**Report: Deficiency Report**  
**Function: Test, Adjust, & Balance**  
**Date: 12/11/2024**  
**Completed By: National TAB**

## 12-09-2024 FREDDY'S - HUNTSVILLE, AL

- EF-1
- EF-1 & EF-2 Backdraft damper
- EF-2
- Gas Piping
- KEF-1 Grease Pan
- KEF-2 Bolts
- KEF-2 Grease Pan
- RTU-1 Final Filter
- RTU-1 Ventilation Noise

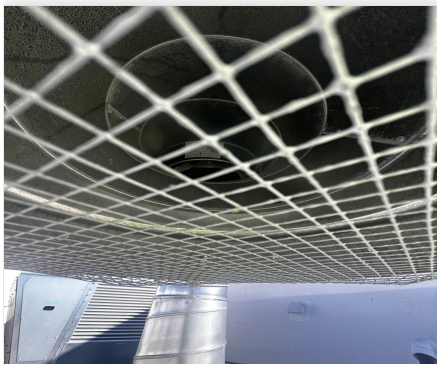
**Issue Name :** EF-1  
**Description :** EF-1 is not wired to power. Unable to balance unit until this is resolved.  
**Created By :** National TAB                      **Assigned To :** National TAB - Kristopher Passley  
**Status :** Closed  
**Priority :** Urgent                                      **Asset Tag :**  
**Originated Date :** 12/12/2024 - Kristopher Passley - National TAB

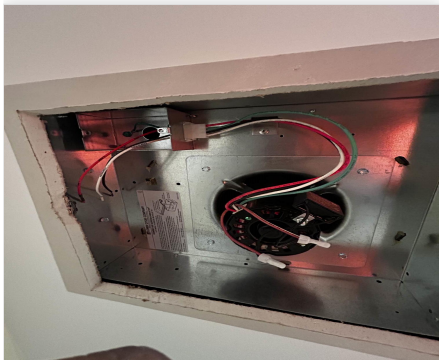
**Issue Name :** EF-1 & EF-2 Backdraft damper  
**Description :** Back draft damper is not installed. Recommend mechanical install as per plans. See plans MP0>14. Exhaust fans:> "B"  
**Created By :** National TAB                      **Assigned To :** National TAB - Kristopher Passley  
**Status :** Open  
**Priority :** High                                      **Asset Tag :**  
**Originated Date :** 12/12/2024 - Kristopher Passley - National TAB
